**RE: Koch Exploration Company, Permit NM-02-0001
Centralized Evaporation Pond #2
SE/4 NW/4 Section 26, Township 32 North, Range 9 West, NMPM,
San Juan County, New Mexico.**

RE: 711 Centralized Waste Management Facility Inspection (NM-02-0001)
Koch Exploration Company, Koch #2 Evaporation Pond
SE/4 NW/4 of Section 26, Township 32 North, Range 9 West, NMPM,
San Juan County, New Mexico

**ATTACHMENT 1
INSPECTION REPORT
JUNE 12, 1997
KOCH EXPLORATION COMPANY, KOCH #2
(SE/4 NW/4 of Section 26, Township 32 North, Range 9 West, NMPM)
SAN JUAN COUNTY, NEW MEXICO**

PHOTO NO. 1 DATE: 06/12/97

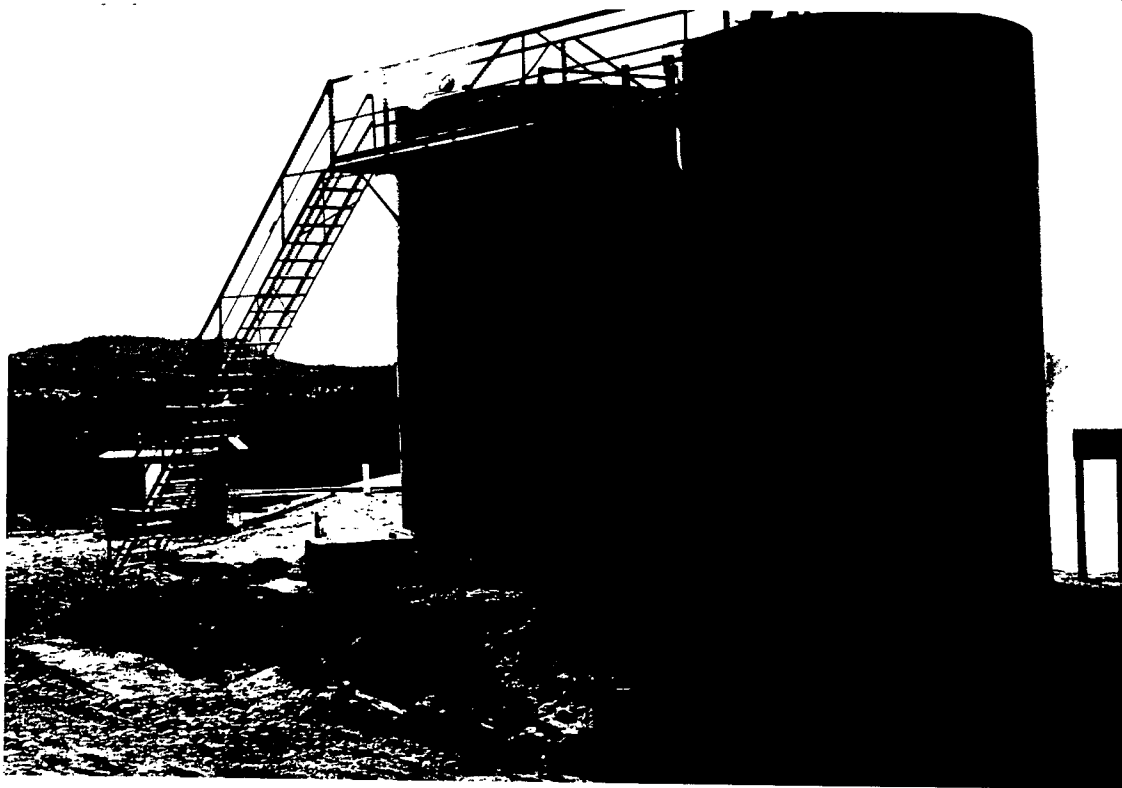
The berms around the above ground tanks need to be repaired and increased either in height or area to hold the appropriate volume (see picture 1). The emergency containment can be directed into the evaporation pond if so desired (see picture 3).

The above ground tanks are not appropriately labeled as to their contents or the hazards of the contents (see pictures 1, 3 and 6). Hazard placards are required on all above ground tanks not containing fresh water.

The facility tanks were clean with no overtopping stains (see picture 1, 3 and 6). Overall yard maintenance and spill prevention/cleanup was good.

PHOTO NO. 3 DATE: 06/12/97

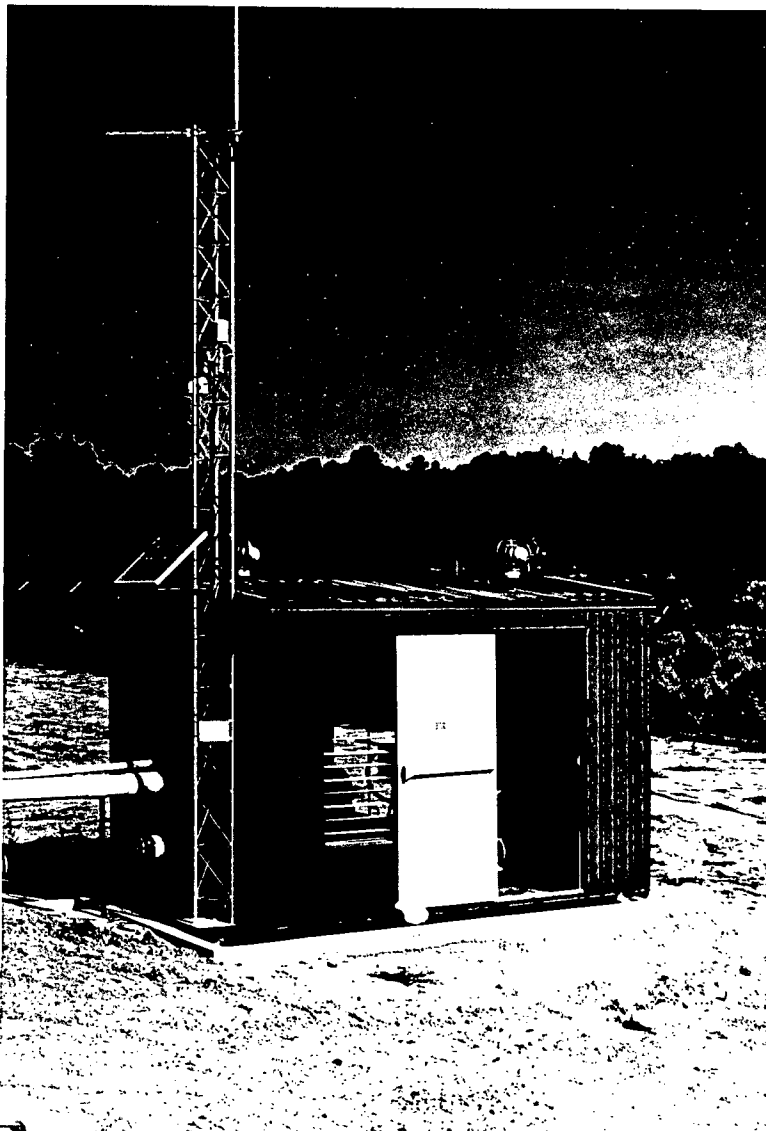
The evaporation pond is lacking freeboard markers that accurately measure the two foot (2') freeboard height (see pictures 2, 3, 5 and 6). Water level was well below freeboard at the time of inspection.

PHOTO NO. 5

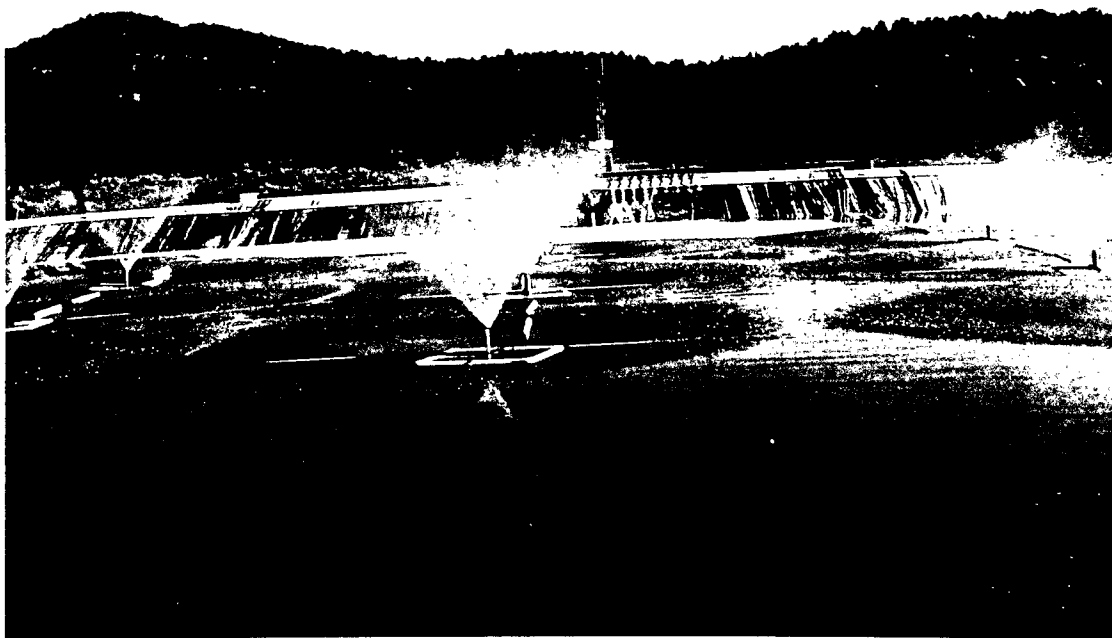
The evaporation pond did not contain any oil (see pictures 2, 3, 5 and 6). Netting
